Road Safety Audit Report

**Incorporating
Stage 1/2 Completion of Detail Design; and
Design Organisation Response to items raised**

Proposed Continuation of Coldharbour Farm Road Emsworth

Client:
Doswell Projects

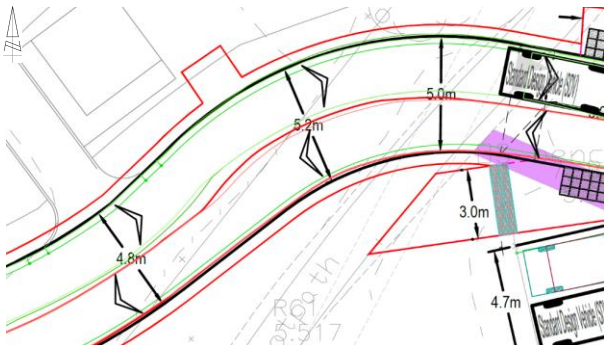
B.1	LOCAL ALIGNMENT
B.1.1	PROBLEM
Location:	Proposed continuation
Summary:	Alignment may not be adequate for two-way car / LGV movements
Acc Type:	Sideswipe type collisions
<p>The scheme drawings provided with the Audit Brief, include a swept path analysis of various vehicles travelling along the proposed continuation to include large vehicles. It is noted that the large vehicles do encroach the entire carriageway and therefore opposing vehicles must stop and wait. This is common practice in residential estates where speeds are low and intervisibility is achievable. The scheme drawings illustrate that intervisibility is achievable between locations where the vehicles can pass. It is noted, however, that there is minimal margin for error where two cars passing one another around the bends in the road. It is noted that the vehicles utilised are the accord with the requirements of TG2, however, the swept paths encroaching the proposed kerblines in places with just 250mm separating the opposing vehicles. Motorists approaching a tight bend in the road will stop and proceed cautiously when a large vehicle is observed, however, the Audit Team have concerns that car drivers will be less cautious and will attempt to pass an opposing car which could lead to sideswipe type collisions.</p>

RECOMMENDATION:	
It is recommended that the carriageway is adequate for cars and LGVs to pass one another.	
Location Plan:

Agree – Paul Basham Associates have prepared a revised tracking drawing on the updated scheme proposals (drawing 187.0018.0003) which demonstrates improved swept paths and ability for cars and vans to pass each other in accordance with HCC TG2 guidance.

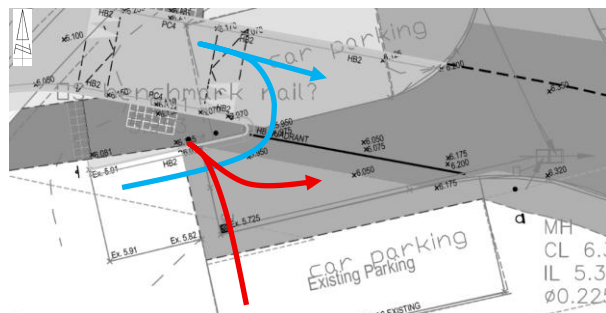
Summary: Vehicles may not be able to access the existing parking bays.

The proposals include the continuation of Coldharbour Farm Road where a number of parking bays are provided both sides of the carriageway. The existing parking cul-de-sac off the northern

side is to remain largely unchanged with a 6.0 metre aisle that allows for easy access to each bay and an edge of carriageway marking provided which will highlight priorities. It is noted, however, that the parking bays to the south of Coldharbour Farm Road do not benefit from an aisle that is of adequate width to allow a car to turn (6 metres). Motorists wishing to access the existing bays, will therefore be required to reverse off or onto the Coldharbour Farm Road carriageway. Speeds will be low and therefore motorists should become aware of one another and proceed accordingly. The Audit Team have concerns, however, that a vehicle will be required to encroach the proposed uncontrolled crossing or shared footway cycleway when manoeuvring into / out of the existing spaces which could lead to vehicle to non-motorised user type collisions.

It is recommended that the bays are accessible.

Agree – The proposed crossing has been relocated circa 1.5m west of the previously proposed location, providing greater separation between the parking areas and crossing. The space to the west of the parking area has been removed and will be replaced with grass, whilst the retained bays have been reduced to 4 wider spaces to allow for improved manoeuvring. Updated car park tracking is provided in drawing 187.0018.0002

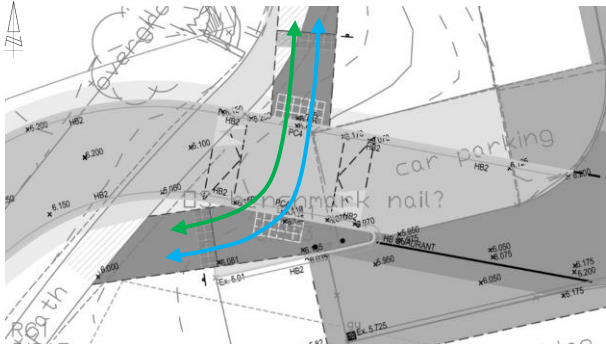
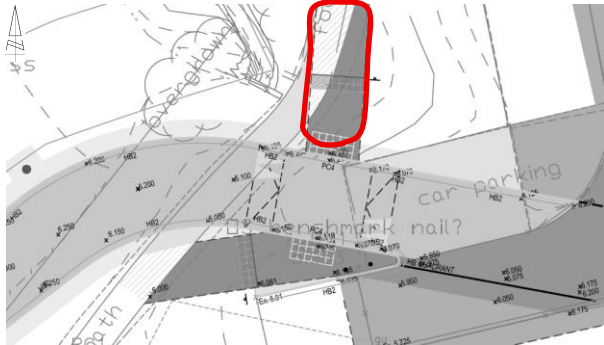
Summary: Cyclists are likely to continue without giving way to traffic

To the west of Coldharbour Farm Road, an existing shared footpath (ref: 108/71/1) is present. This route provides access between the residential area of Emsworth to the south of the A27 and leisure facilities to the north to include Emsworth Park. This route is utilised by pupils and parents / guardians of the local primary school as well as pedestrians and cyclists with numerous cyclists

observed during then site visits associated with the scheme. The proposals include the continuation of Coldharbour Farm Road to form a development access which severs the existing footpath. The scheme drawing details that an uncontrolled crossing is to be provided on a raised table. Whilst non-motorised users should stop at an uncontrolled crossing and not proceed until it is safe to do so, the Audit Team have concerns that cyclists as well as some pedestrians will proceed without stopping which could lead to vehicle to non-motorised user type collisions. It is understood that cyclists should not utilise the existing footpath, however, it is a fact that they do.

It is recommended that an appropriate level of visibility is achievable.

<p>drawing illustrates that visibility splays of 2.4x43 metres are achievable from the uncontrolled crossing, however, they do not extend to the tangent and it is noted that the footpath is not illuminated. The Audit Team have concerns that visibility of a non-motorised users immediately approaching the proposed uncontrolled crossing is limited, particularly during the hours of darkness which could lead to a vehicle to pedestrian type collision.</p>	
<p>RECOMMENDATION:</p>	
<p>It is recommended that visibility is achievable to the tangent and that the proposed crossing point is illuminated adequately with a column provided immediately to the west of the crossing point as previously proposed.</p>	
<p>Location Plan:</p>	
<div></div>	
<p>DESIGN ORGANISATION RESPONSE provided by PBA on the 1st July 2026 following formal issue of this Stage 1/2 Road Safety Audit on the 26th March 2026</p>	
<p>Agree – The crossing has moved 1.5m west of the previously proposed location, and visibility to the tangent has been demonstrated on drawing 187.0018.0001. Whilst street lighting is a detailed matter to be considered through the S278 design, the street lighting designer for the scheme has confirmed that the lighting column implemented adjacent to the substation will have sufficient luminance levels to appropriately light the crossing.</p>
